Bid Addendum No. 2 for:

MASON TRANSIT AUTHORITY – PARK AND RIDE CONSTRUCTION PROJECT

All Bidders are required to make the following substitutions to the Bid Documents. Below is a description of the revisions made to the Contract Documents.

DRAWING No.: IL-1
 SHEET No.: 23 OF 86

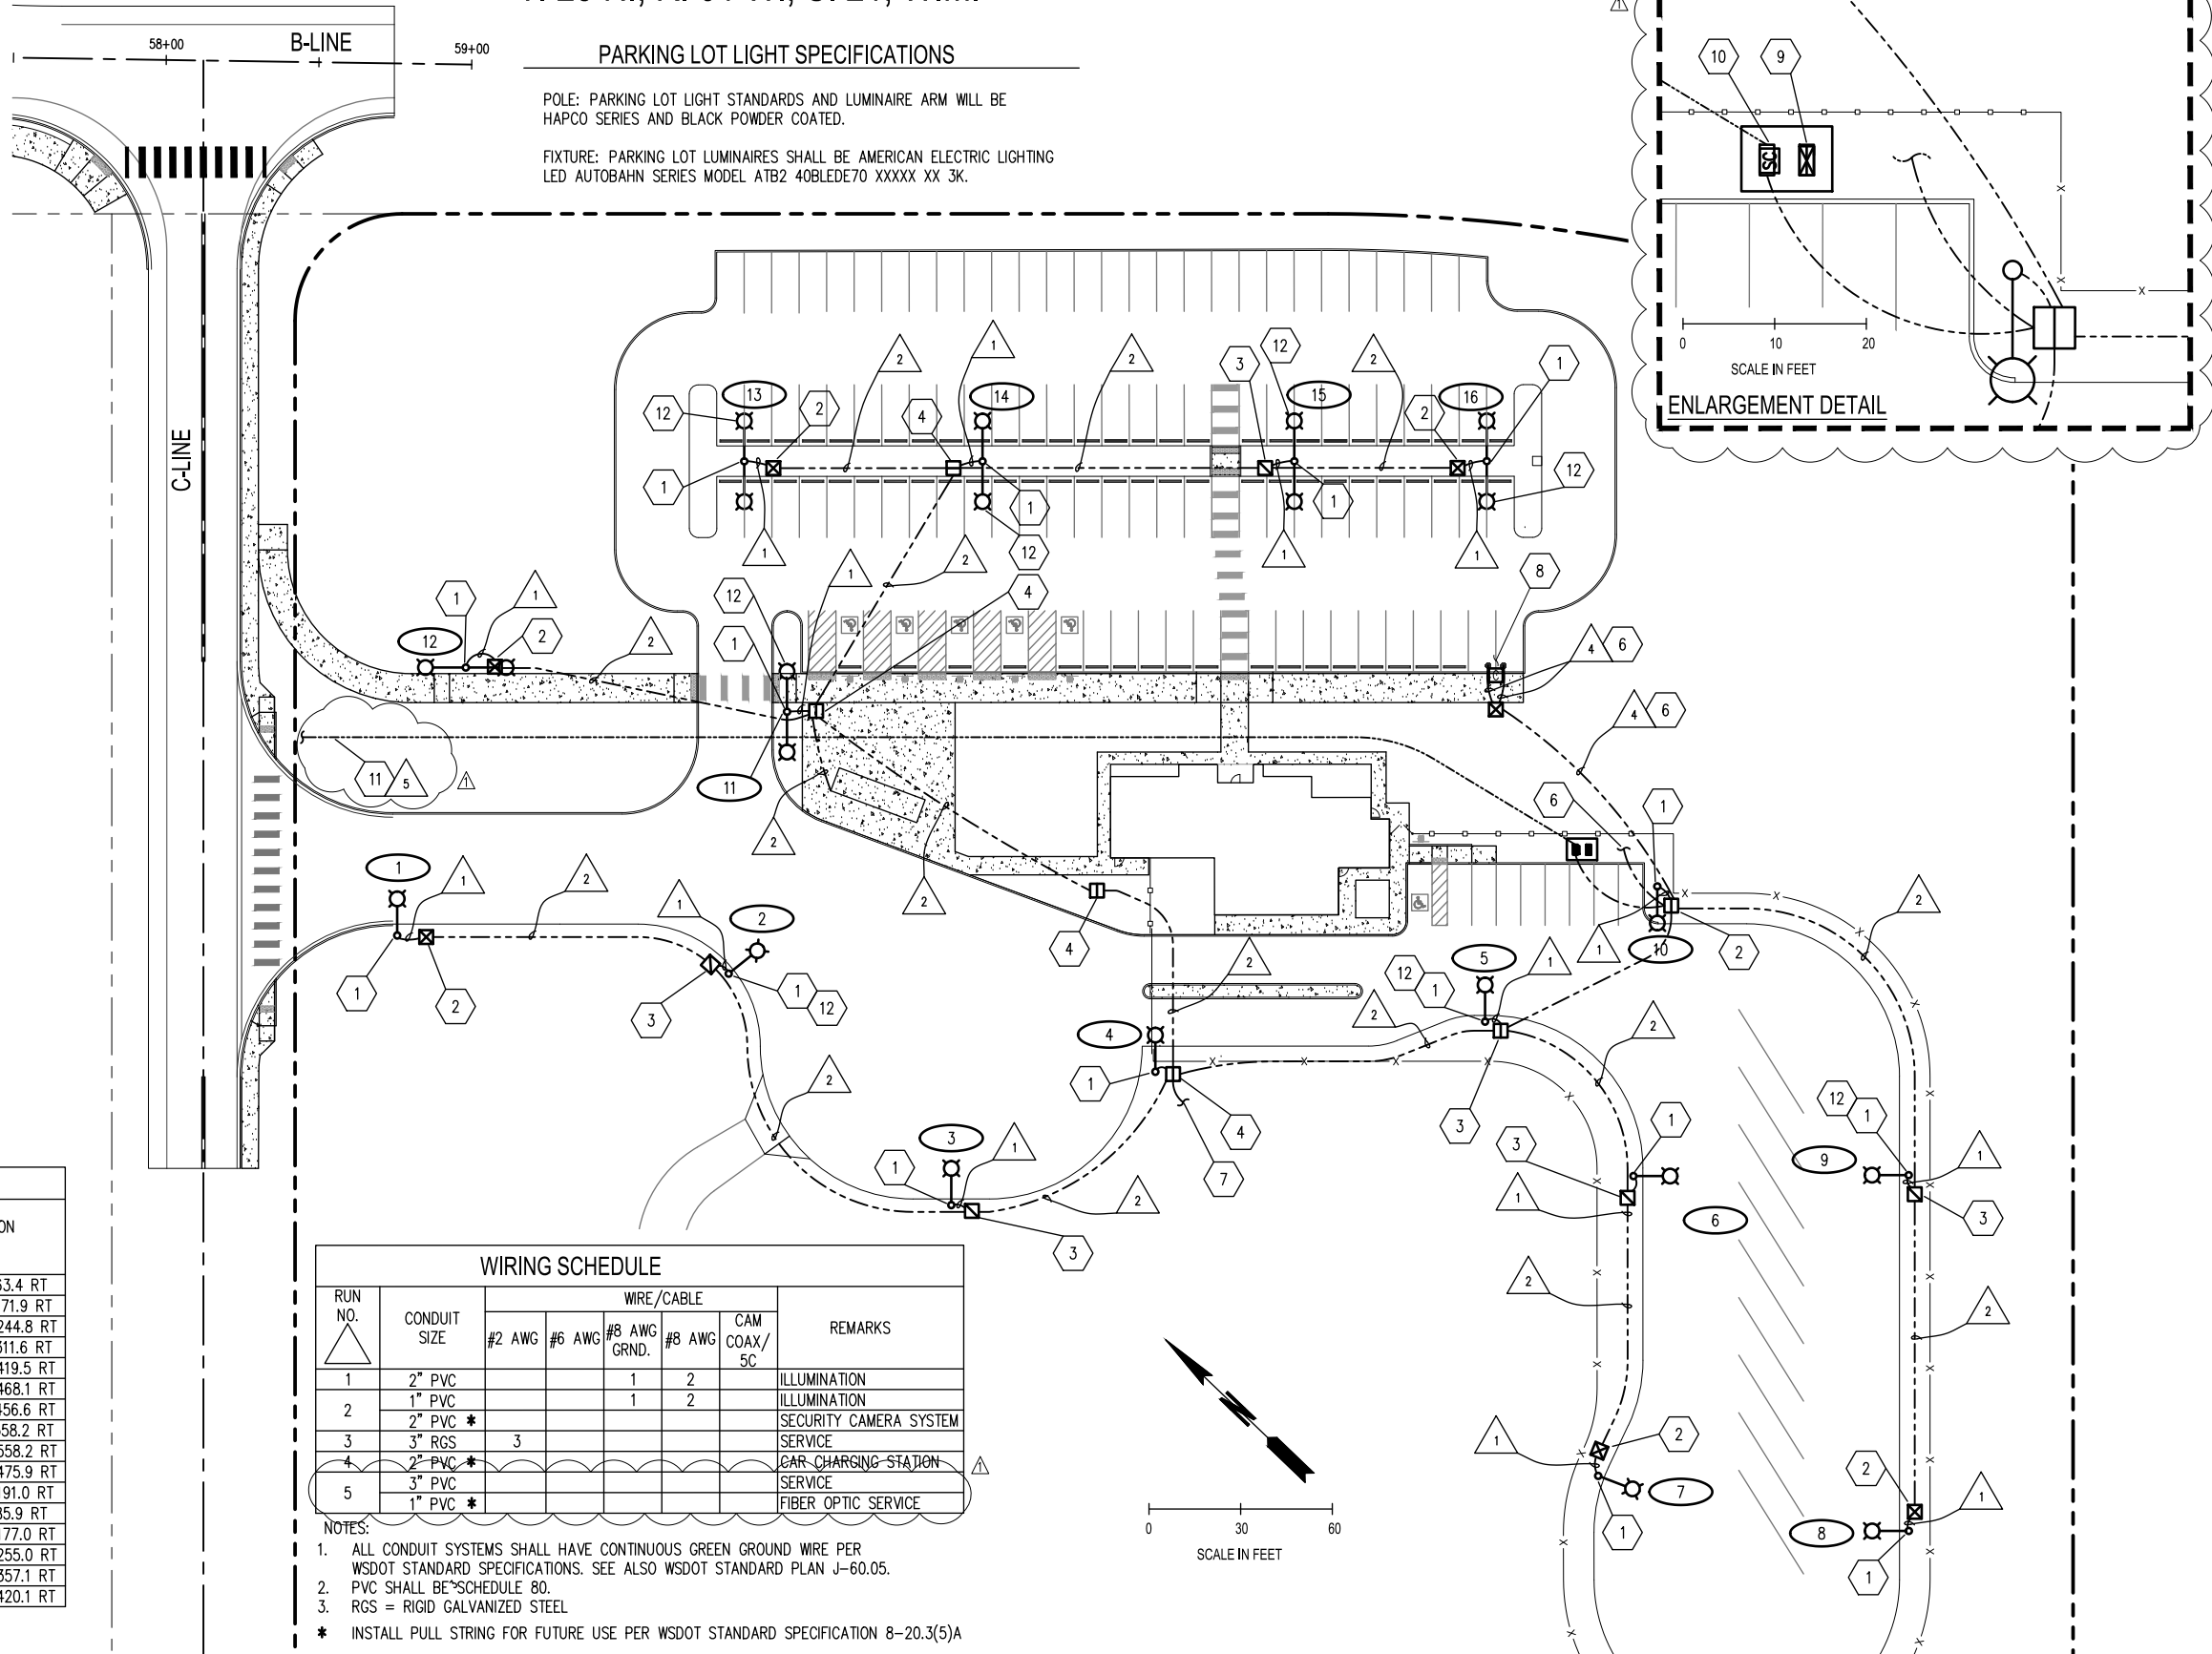
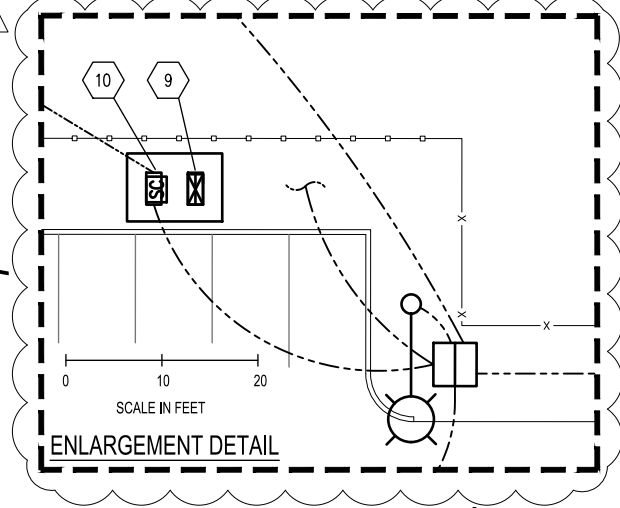
- Sheet II-1: Replace with attachment II-1 to include enlargement detail and modified luminaire heads with security camera model.
- Sheet E5.1A and E5.1B: **ADD** to Feeder Schedule:
Call-out 200-4 indicates 2”C – 4 #3/0 (CU conductors)

DRAWING No.: IL-1
SHEET No.: 8 OF 9

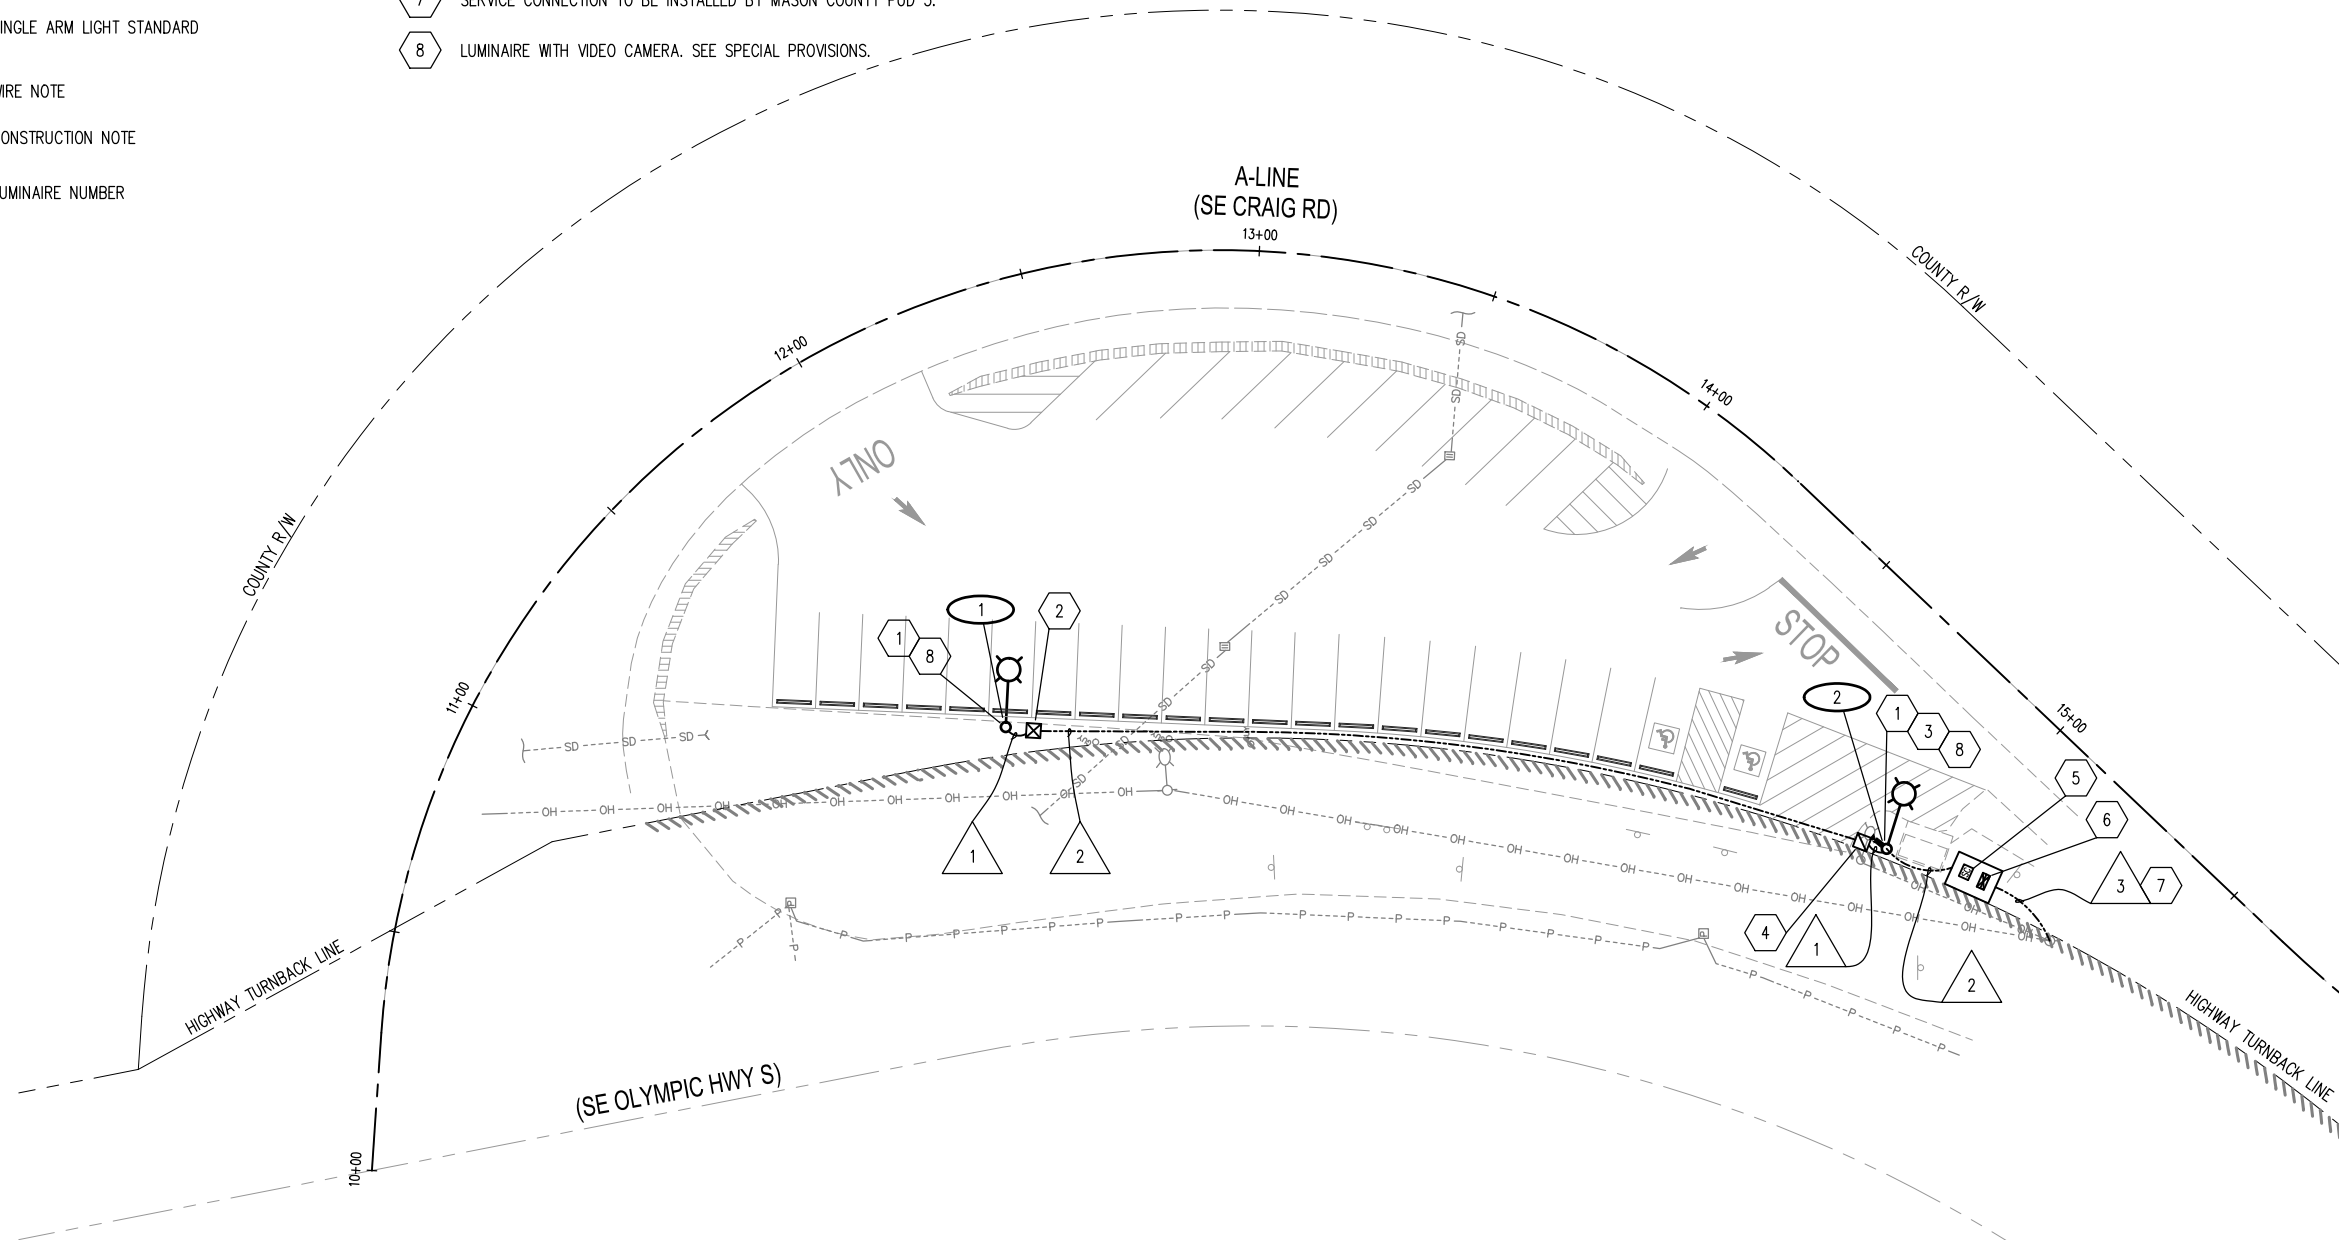
- Sheet II-1: Replace with attachment II-1 to include modified luminaire heads with security camera model.

DRAWING No.: IL-1
SHEET No.: 11 OF 12

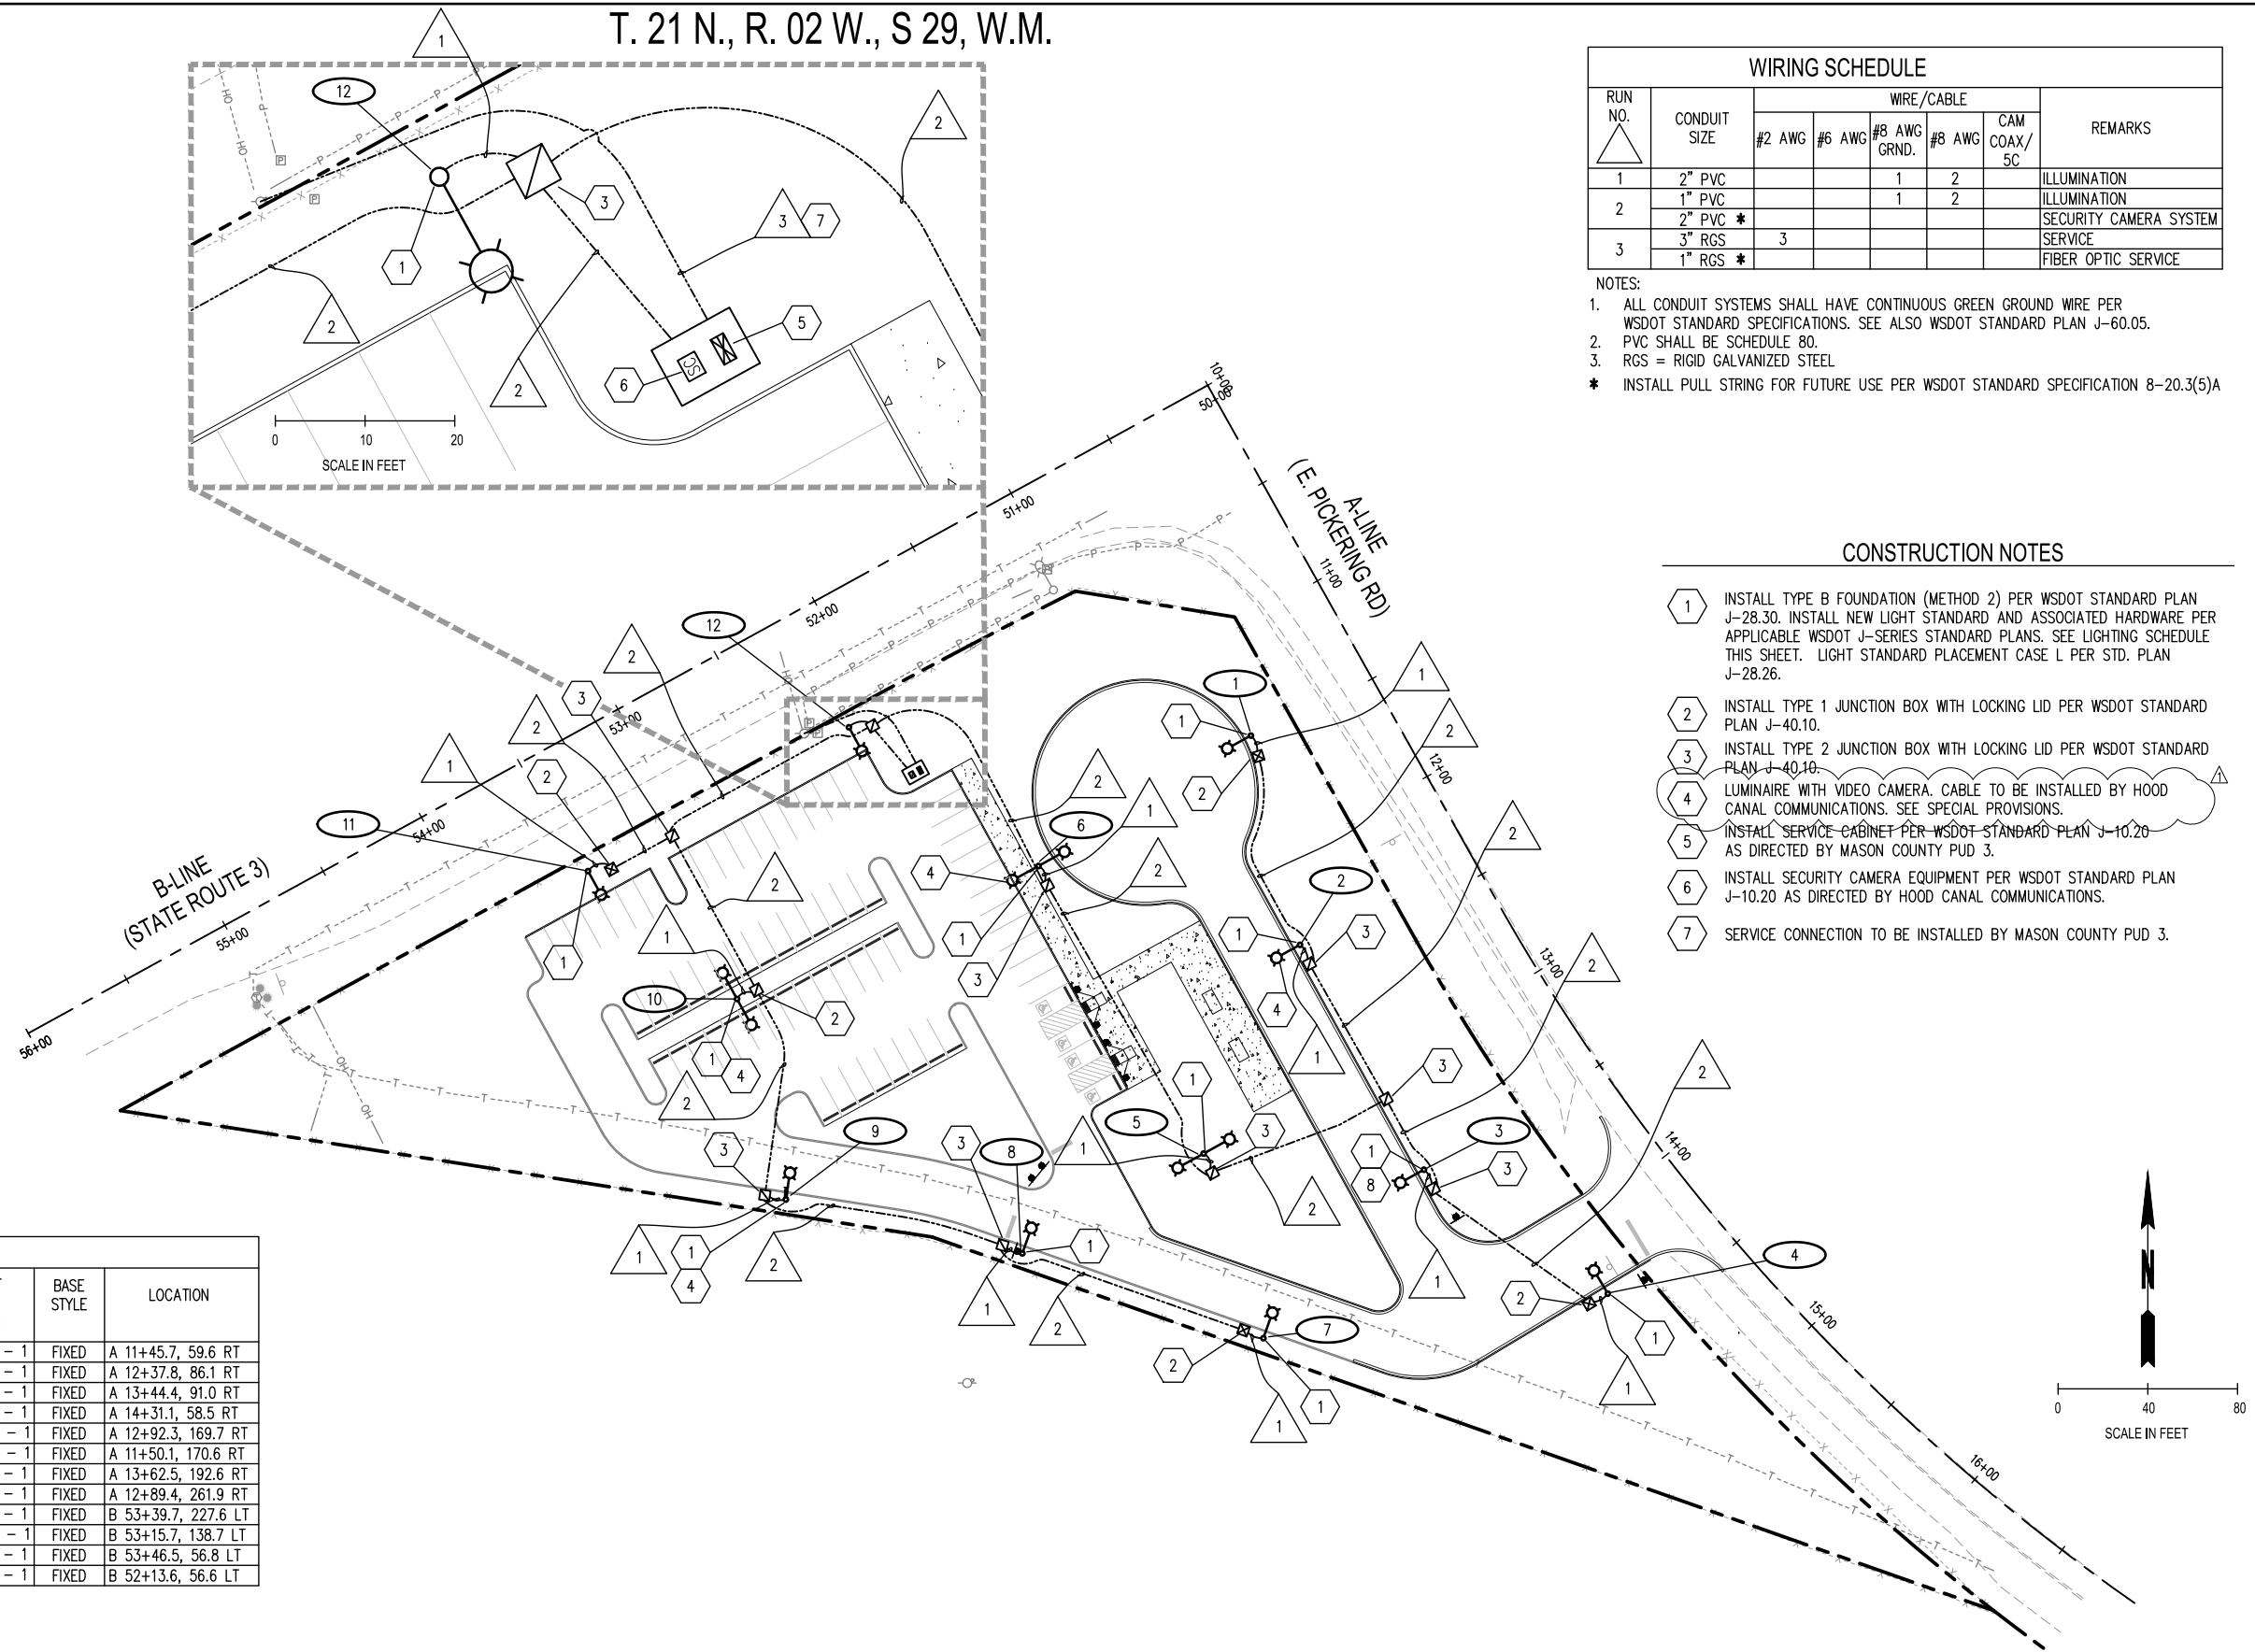
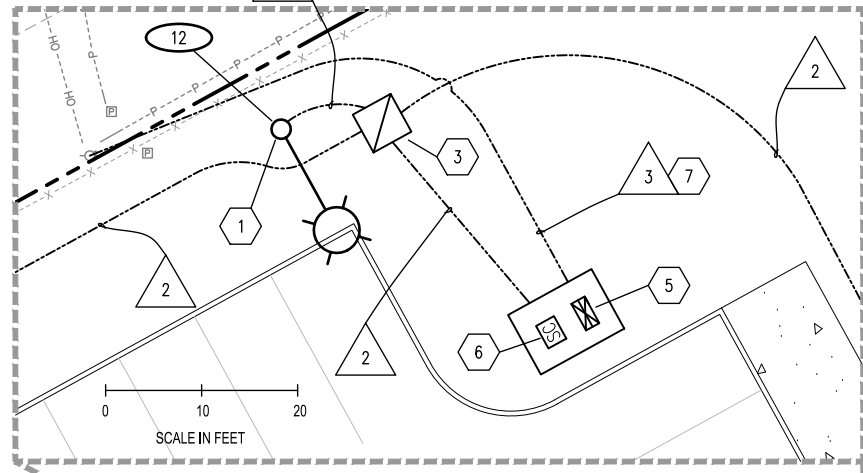
- Sheet II-1: Replace with attachment II-1 to include modified luminaire heads with security camera model.
